STAFF RECOMMENDATION
1821 4th Avenue North
March 17, 2021

Application: New Construction—Addition and Outbuildings
District: Salemtown Neighborhood Conservation Zoning Overlay
Council District: 19
Base Zoning: R6-A
Map and Parcel Number: 08108029200
Applicant: Kent Basile
Project Lead: Melissa Baldock, melissa.baldock@nashville.gov

<p>Description of Project: Applicant proposes to construct a rear addition and two detached outbuildings.</p> <p>Recommendation Summary: Staff recommends approval of the project with the following conditions:</p> <ol style="list-style-type: none"> 1. The addition tie into the roof at least six inches (6”) below the ridge and six inches (6”) from the sides of the historic roof; 2. The main front window be a picture window with a transom or a pair of double hung windows, a window be added to the right façade towards the front of the house, and the horizontal window on the left façade become a square or a vertical window; 3. All paired window openings have a four inch to six inch (4”-6”) mullion in between them; 4. Staff approve the windows and doors and roof shingle color prior to purchase and installation; and 5. The HVAC be located behind the house or o

Figure 3 (left) shows the door off the front porch that will be a window. Figure 4 (right) shows the proposed design.

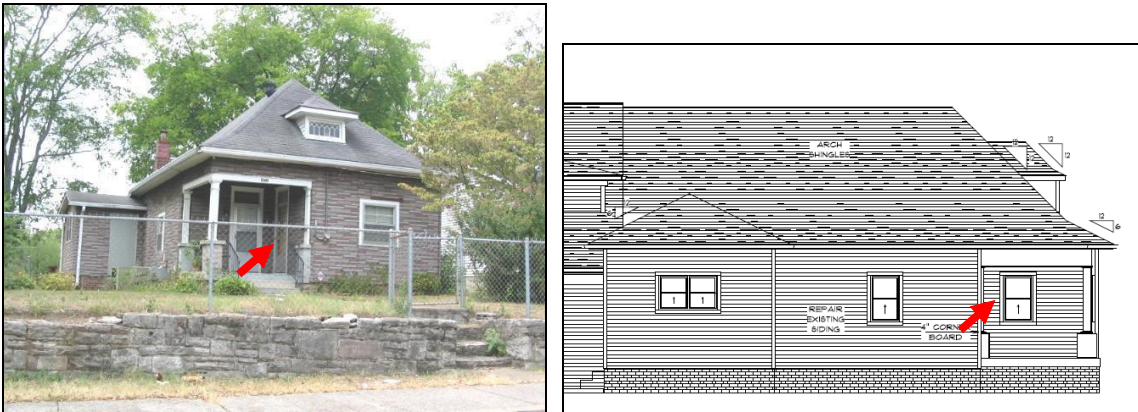
Partial Demolition. The applicant proposes to convert an existing side door off of the front porch into a window. This is considered partial demolition. Staff finds this alteration to be appropriate because the door does not face the street and because there will still be an opening in that location. Staff therefore finds that this partial demolition meets the design guidelines. The applicant also proposes to remove the door on the non-historic side extension, which meets the design guidelines because this part of the house is not historic.

Staff finds that the proposed partial demolition meets Section V.B.2. of the design guidelines for appropriate demolition.

Right and Left Elevations
Scale 1/8" = 1' ON 11"x17" PAPER
Scale 1/4" = 1' ON 24"x36" PAPER

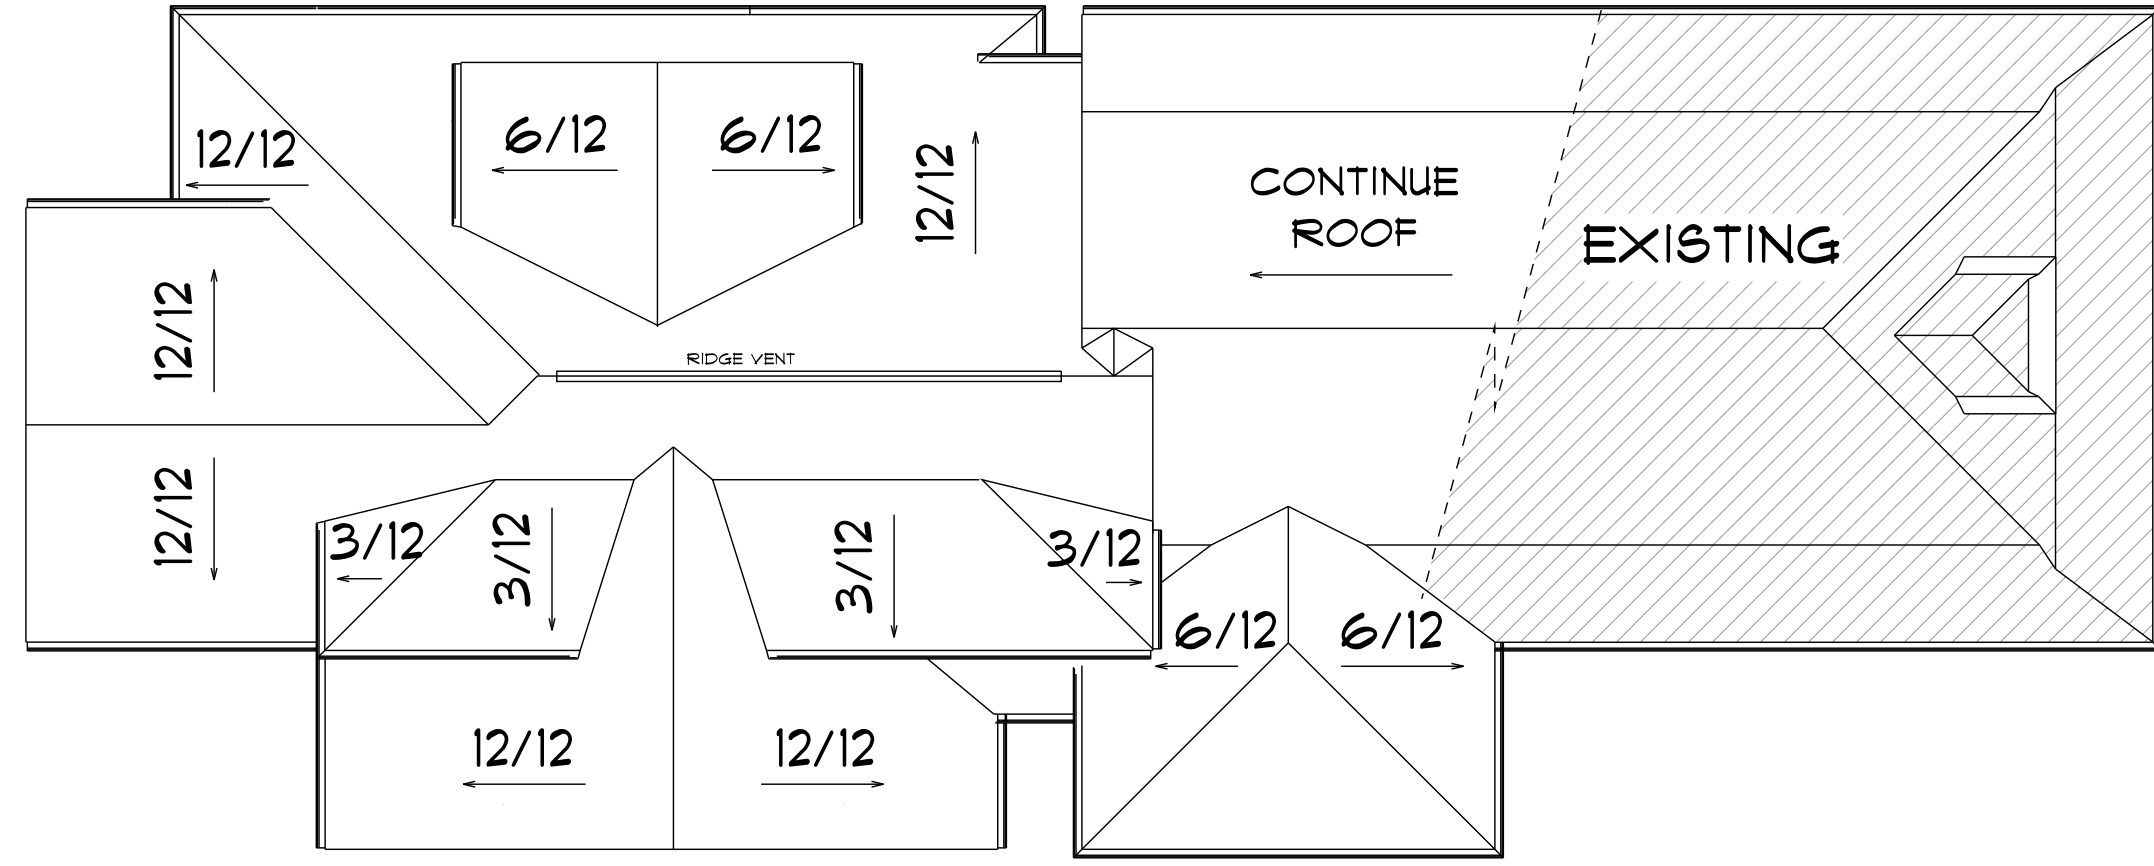
Proportion and Rhythm of Openings: No changes to the window and door openings on the existing house were indicated on the plans. On the historic house, many of the openings were changed when the house was altered in the mid-twentieth century. Staff recommends that the main front window be a picture window with a transom or a pair of taller double hung windows, matching a typical window opening for a folk Victorian house like this one. Staff also recommends the inclusion of a window on the right façade, towards the front of the house.

On the addition, staff recommends that the horizontal window on the left façade become a square window to meet the historic proportion of window openings. In addition, all paired window openings shall have a four to six inch (4”-6”) mullion in between them. With these changes, staff finds that the windows on the addition meet the design guidelines.

1. The addition tie into the roof at least six inches (6”) below the ridge and six inches (6”) from the sides of the historic roof;
2. The main front window be a picture window with a transom or a pair of double hung windows, a window be added to the right façade towards the front of the house, and the horizontal window on the left façade become a square or a vertical window;
3. All paired window openings have a four inch to six inch (4”-6”) mullion in between them;
4. Staff approve the windows and doors and roof shingle color prior to purchase and installation; and,
5. The HVAC be located behind the house or on either side, beyond the mid-point of the house, and utility meters shall be located on the side of the building, within 5’ of the front corner. Alternative mechanical and utility locations must be approved prior to an administrative sign-off on building permit(s).

Roof Plan
Scale 1/8" = 1'
Scale 1/4" = 1'
ON 11"x17" PAPER
ON 24"x36" PAPER

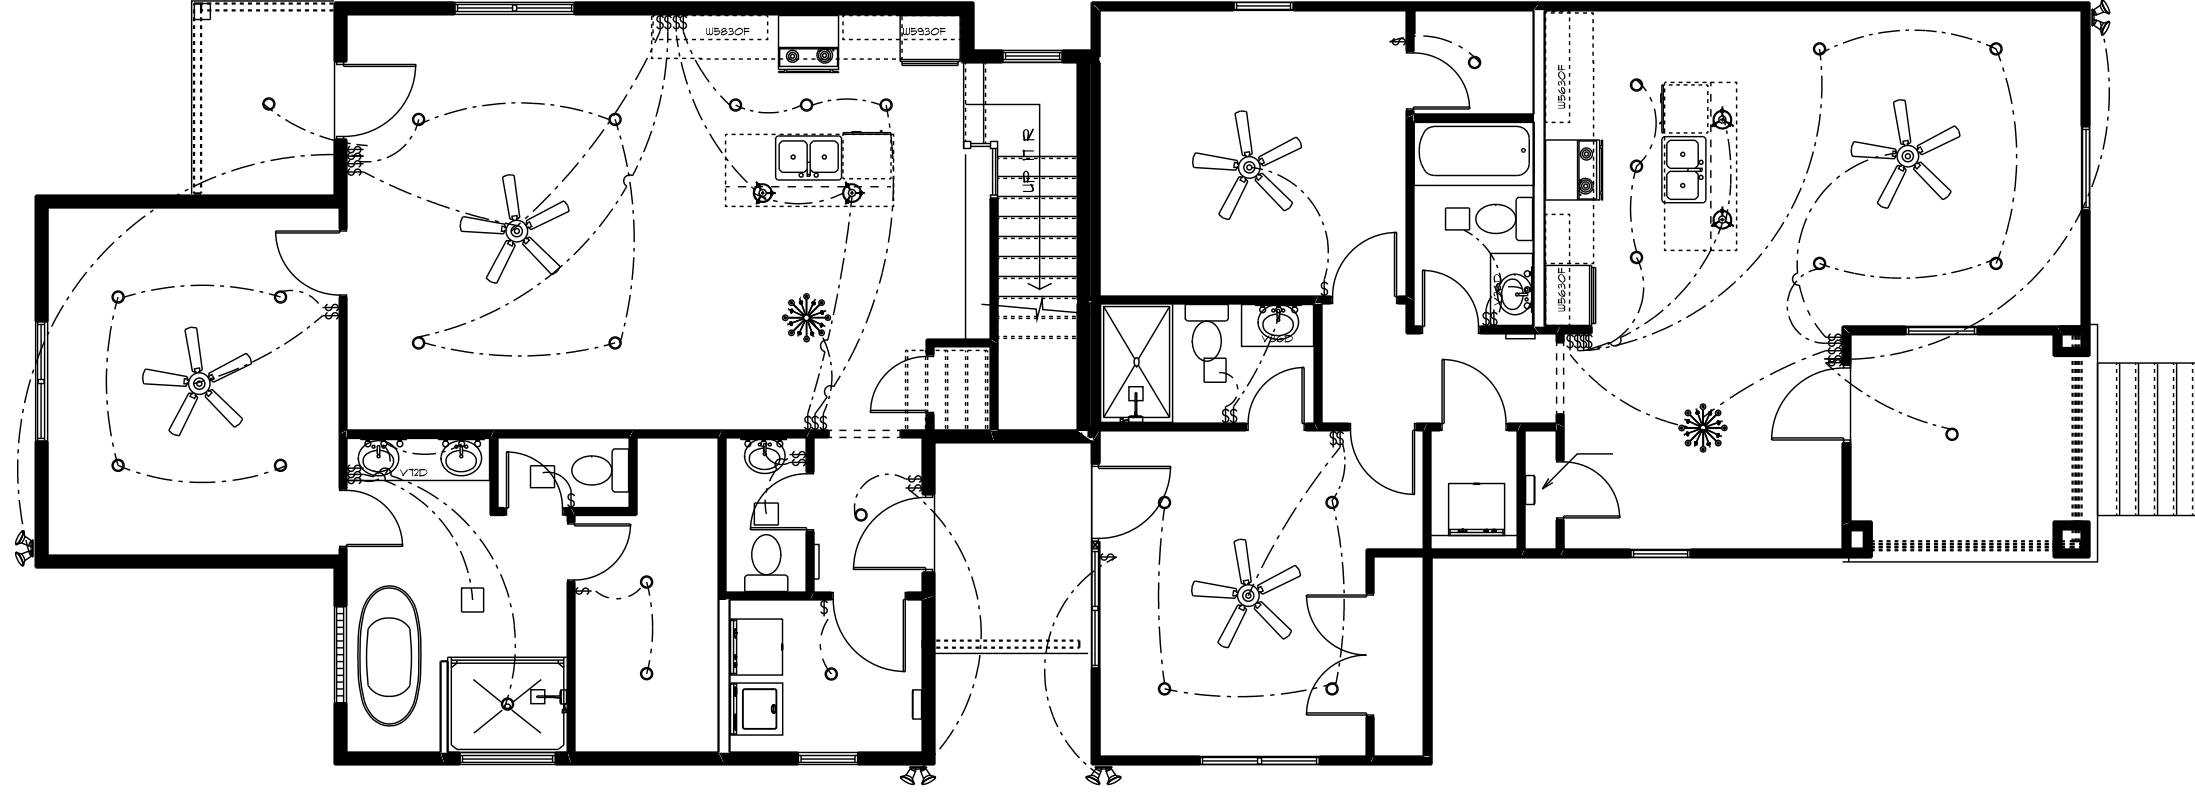
The addition's roof form does not tie into the historic roof in a manner that preserves the form of the historic house. Staff recommends that the addition tie into the roof at least six inches (6") below the ridge and six inches (6") from the sides of the historic roof. With this condition, staff finds that the addition's height and scale to meet Sections III.A, III.B., and IV. of the design guidelines.

Roof form: As previously mentioned, the addition’s roof is not differentiated from the roof of the historic house. Staff recommends that the addition tie into the roof at least six inches (6”) below the ridge and six inches (6”) from the sides of the historic roof. The addition’s gabled and hipped forms are compatible with the historic house’s hipped form. The dormers are all inset at least two feet (2’) from the historic side walls of the house.

With the condition that the addition tie into the roof at least six inches (6”) below the ridge and six inches (6”) from the sides of the historic roof, staff finds that the addition’s location and removability to meet Sections IV.A. and IV.F. of the design guidelines.
